## Todd Prager & Associates LLC

### MEMORANDUM

**DATE:** October 3, 2024  
**TO:** Sam Nisley (Vaughn Bay Construction)  
**FROM:** Todd Prager, RCA #597, ISA Board Certified Master Arborist  
**RE:** Tree Removal and Protection at Cascade Creek Apartments

**Attachment 1**

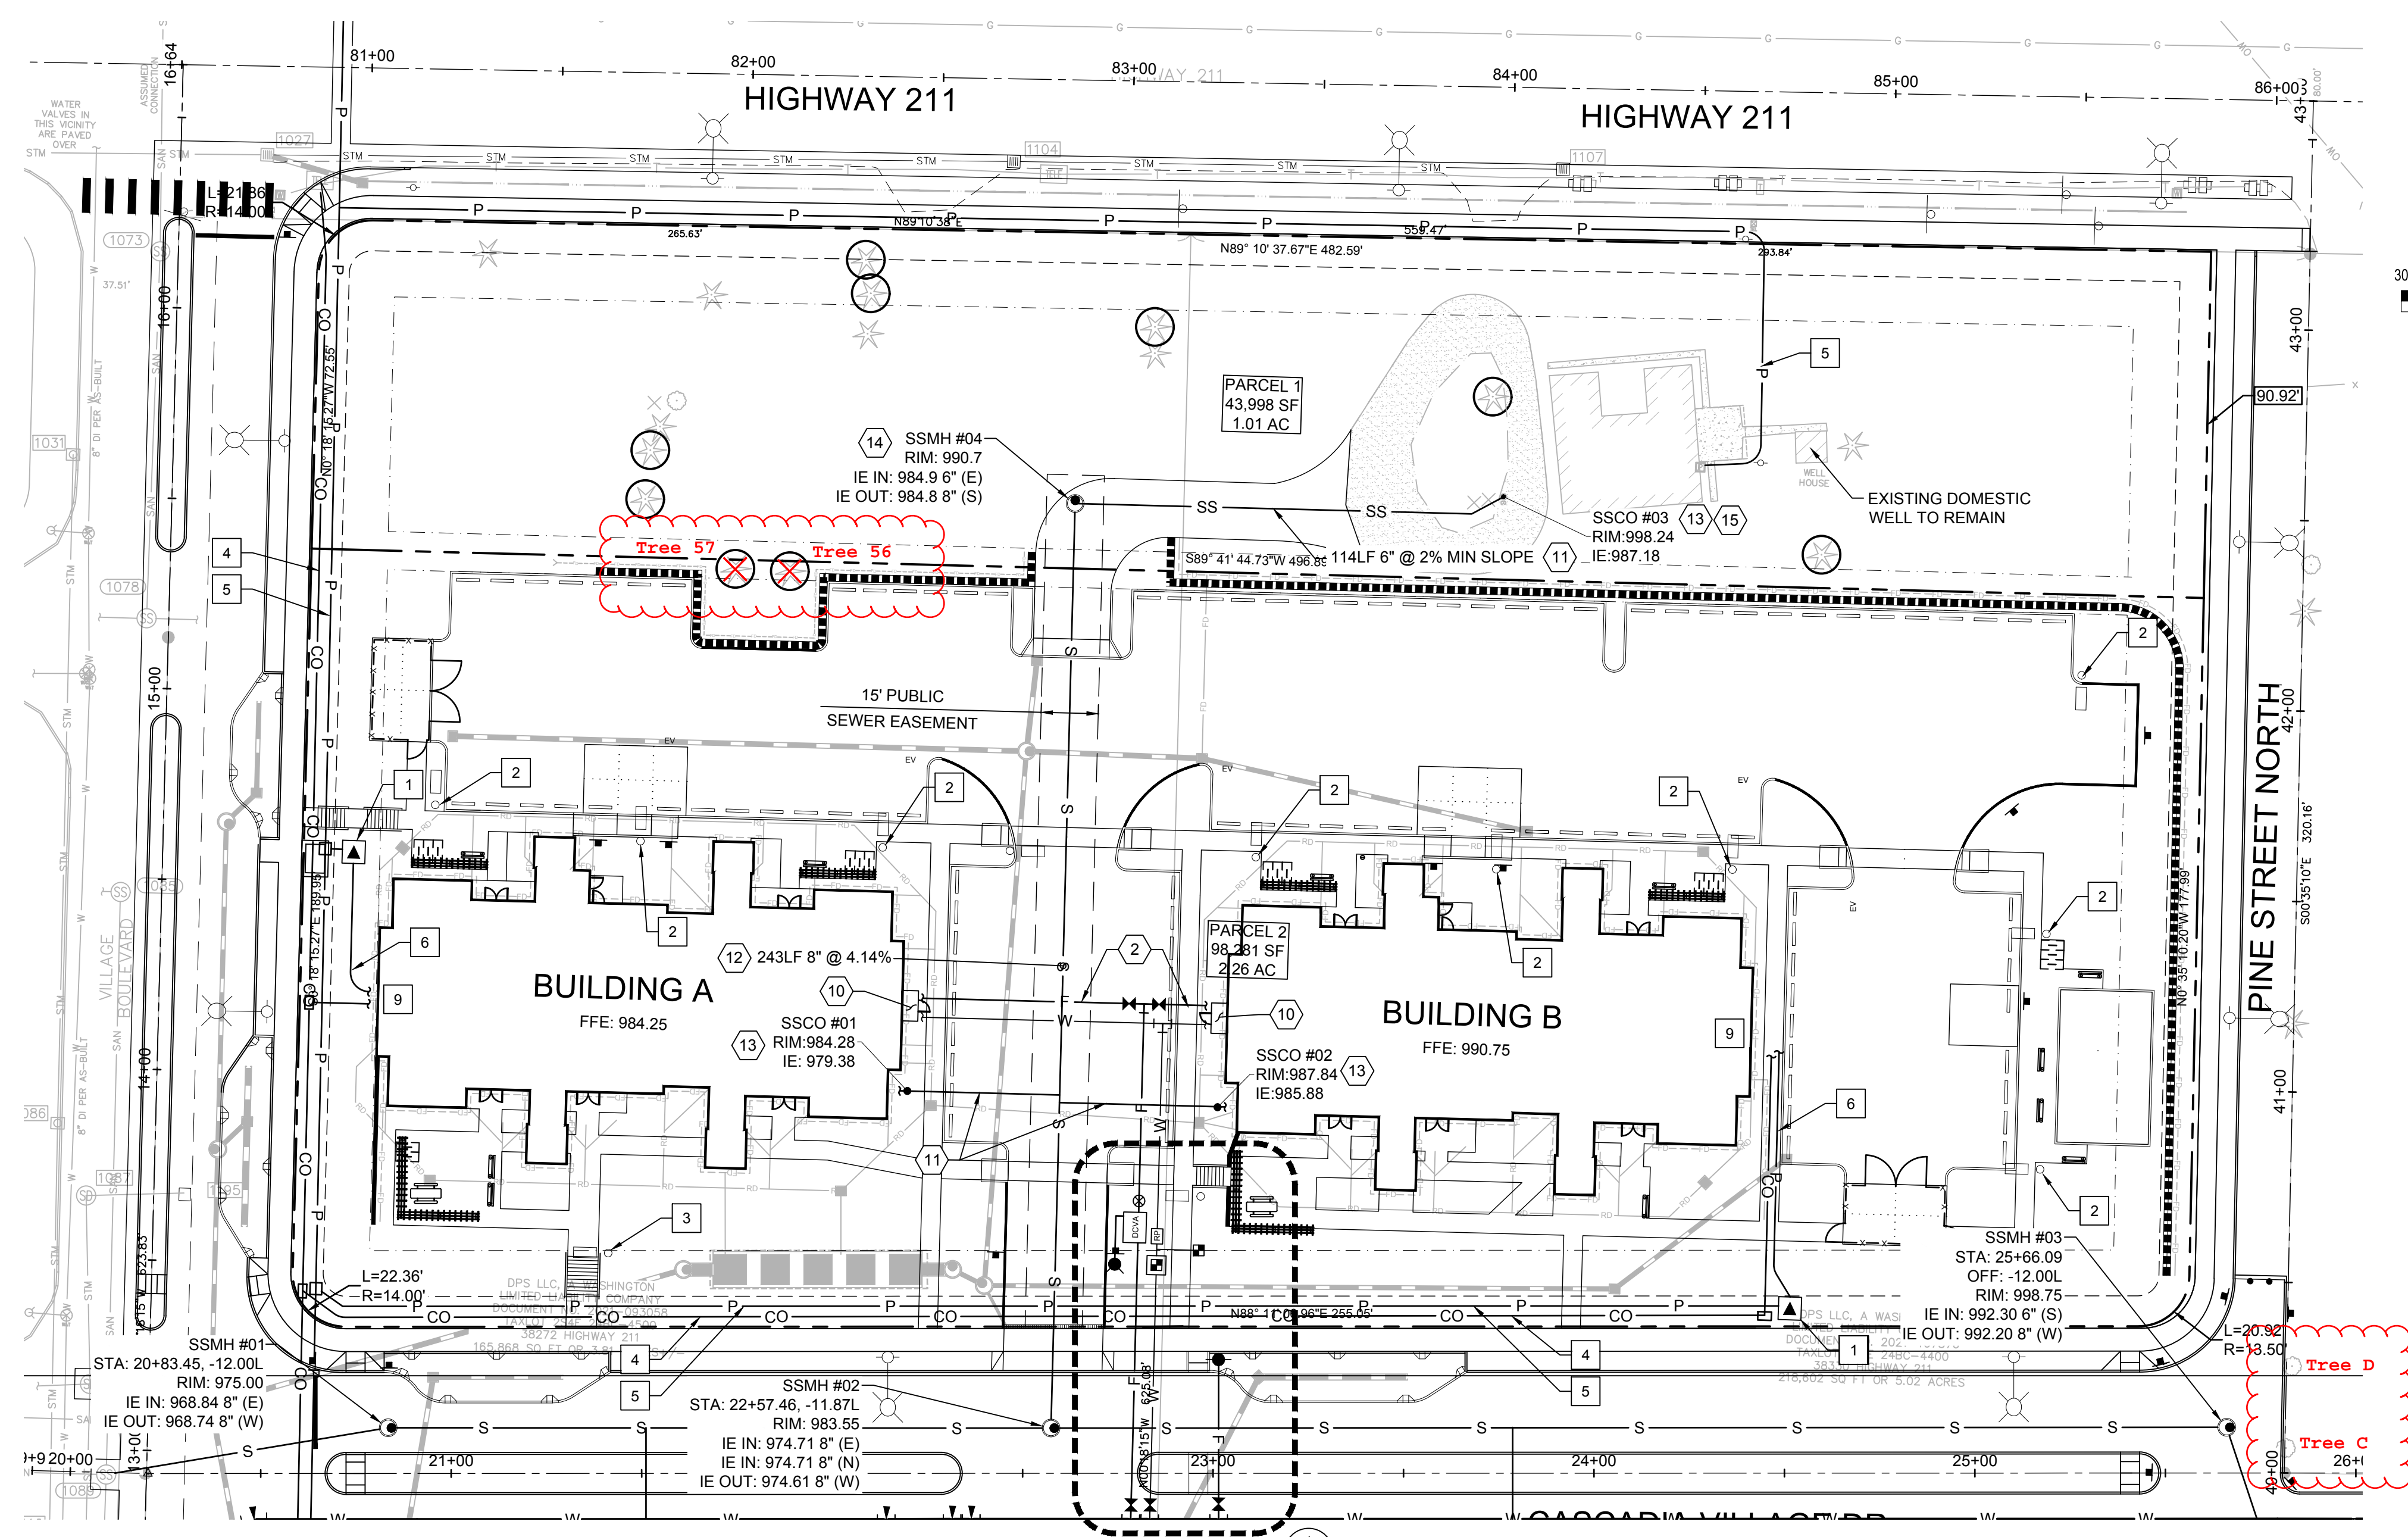
Vaughn Bay Construction is requesting the removal of two trees and clarification of the status of two property line trees at the Cascade Creek Apartments site. The March 7, 2024 civil plan sheet with the subject trees is in Attachment 1. The summary of issues for the subject trees are in Table 1.

This lack of survey for tree locations may explain the discrepancies and conflicts associated with trees 56 and 57 on the civil plans when compared with their locations at the site.

Regarding trees C and D, these two trees were identified for retention in the January 9, 2023 site plan with a curblin bumpout adjacent to both trees as shown in Attachment 2. However, the March 7, 2024 plan in Attachment 1 shows the curblin directly adjacent to the trunks of both trees which would require their removal. Vaughn Bay Construction needs clarification from the City of Sandy whether the curblin can bumpout adjacent to the trees or if the trees require removal. If removal is required, permission from the tree owner will be required.

In summary, trees 56 and 57 conflict with the proposed retaining wall location, likely due to survey error. Since tree 57 is a retention tree, it would be required to be replaced with two native replacement trees. Clarification is needed regarding the curblin adjacent to trees C and D. If the curblin can bumpout, the trees can likely be retained. If the curblin cannot bumpout, the trees will likely need to be removed subject to the approval of tree owner.
